City of Kitchener
Zone Change Comment Form

Address: 1668 King St E

Application #: OPA 21/088/K/CD and ZBA 21/013/K/CD

Comments Of: City of Kitchener – Urban Design- Planning

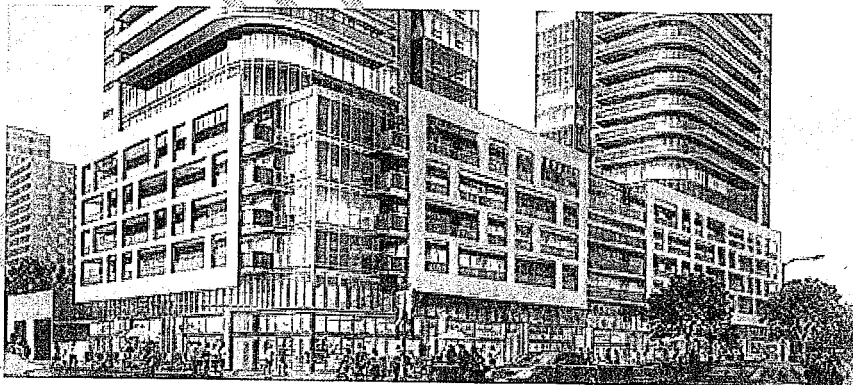
- Enhanced exterior lighting (colored, programmable, patterned, etc.)
- The city is supportive of the approach to use balconies to add a pattern to the tower, to articulate the facades and break down tower massing. Refining these balconies to create the best possible architectural expression for the tower will be critical. Podium levels along King and Weber Street would benefit from balconies for residential units, adding natural surveillance and a greater sense of street life.

Concept Plans - Cusimano Architects drawings SK-00 to SK-17 dated 2021-06-28

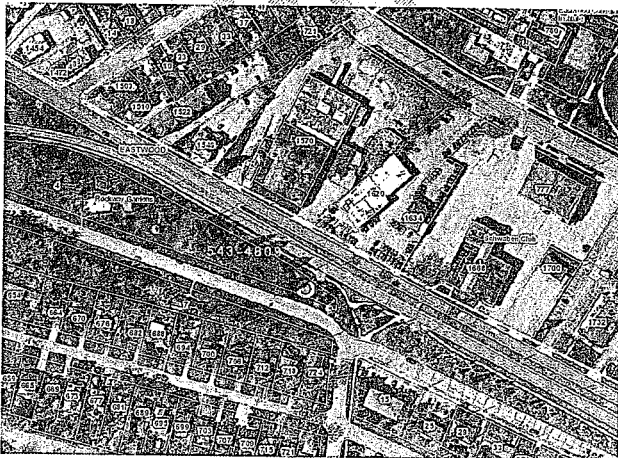
Much of the active parkland in the Eastwood neighbourhood Planning Community is located north of Weber St E and the design of the Weber St E frontage should be reconsidered to accommodate pedestrian movement and provide a landscaped streetscape.

Accommodating through lot access for residents from both buildings and from bicycle storage facilities would improve use of and access to existing and planned neighbourhood multi-use pathways and trails.

A roof on the second floor parking deck should be provided to accommodate additional on-site amenity space.
